# Access Compliance Report

## Public Rights-of-Way

### (Curb Ramps)

Intersection ID: 45504	Main Street: FIRST_BLOOM_RD	Cross Street: MEADOW_BOTTOM_RD	Location: E
ADA ID: 5EC1AA7E26F2	Ramp Type: PerpDiag	Initial Pass/Fail: Fail	Overall Compliance: No
Severity Score: 47.5			
Codes/Mitigation Info/Possible Solution		Field Measurements/Component Compliance

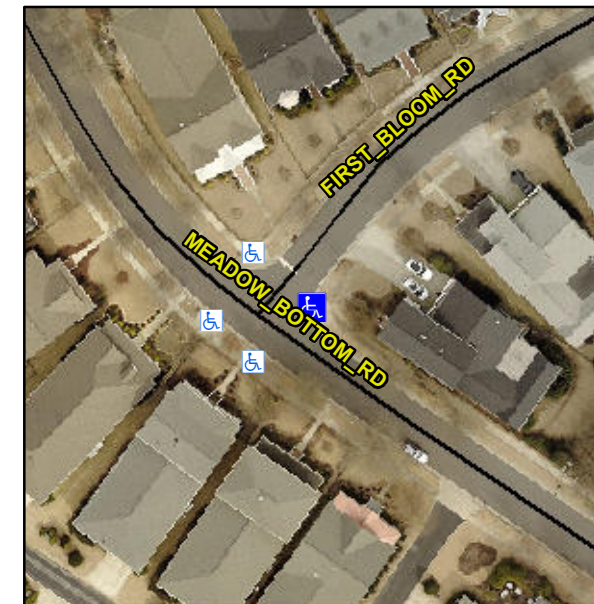
**Not Found, R304.5.1, R304.5.3**

Compliance	Description	Data	Compliance	Description	Data
N/A	Ramp Length (in)	72.0	Yes	Ramp Slope (%)	7.9
No	Ramp Width (in)	30.0	No	Ramp XSlope (%)	5.2
N/A	Flare Type LT	N/A	N/A	Flare Type RT	N/A
N/A	Flare Slope LT (%)	N/A	N/A	Flare Slope RT (%)	N/A
N/A	Flare Traversable LT?	N/A	N/A	Flare Traversable RT?	N/A
N/A	Landing Length (in)	N/A	N/A	DWS Provided?	N/A
N/A	Landing Width (in)	N/A	N/A	DWS Contrast?	N/A
N/A	Landing Slope (%)	N/A	N/A	DWS Length (in)	N/A
N/A	Landing X Slope (%)	N/A	N/A	DWS Full Width?	N/A
N/A	Landing Curb? (Y/N)	N/A	N/A	DWS Offset (in)	N/A
N/A	Shared Landing?	N/A			
N/A	Gutter Ponding?	N/A	N/A	Gutter Slope (%)	N/A
N/A	Gutter Lip Ht (in)	N/A	N/A	Gutter X Slope (%)	N/A
N/A	Painted X Walk1?	No	N/A	Painted X Walk2?	No
	X Walk 1 Direction	To NW		X Walk 2 Direction	To SW
N/A	X Walk 1 Width (in)	N/A	N/A	X Walk 2 Width (in)	N/A
	X Walk 1 Slope (%)	3.9		X Walk 2 Slope (%)	0.3
	X Walk 1 X Slope (%)	0.6		X Walk 2 X Slope (%)	3.4

**Remove & Replace Curb Ramp With Two New Directional Ramps or Equivalent.**
